IOWA DEPARTMENT OF TRANSPORTATION

Subject: Method's Memo No. 186 (Revision Open Rail Details to J24-06, J30-06, J40-06, J44-06)

6j1 bar – Bent Bar Detail

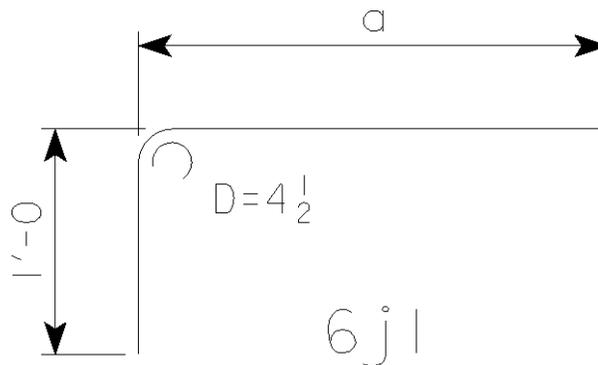
An error has been found in the open rail details on the J24-06, J30-06, J40-06, and J44-06 continuous concrete slab standards. The 6j1 bar should have been shown as a variable bar as shown in the table below. When using the open rail details on the standards the following correction should be made to the length of the 6j1 bar and rebar weight.

| Bridge Length | "a" dimension | Total length | Total number | Revised bar weight |
| 70 | 3'-6 | 4'-6 | 152 | 1027 |
| 80 | 3'-7 | 4'-7 | 184 | 1267 |
| 90 | 3'-8 | 4'-8 | 200 | 1402 |
| 100 | 3'-9 | 4'-9 | 216 | 1541 |
| 110 | 3'-10 | 4'-10 | 232 | 1684 |
| 120 | 3'-11 | 4'-11 | 264 | 1950 |
| 130 | 4'-1 | 5'-1 | 280 | 2138 |
| 140 | 4'-2 | 5'-2 | 296 | 2297 |
| 150 | 4'-3 | 5'-3 | 312 | 2460 |
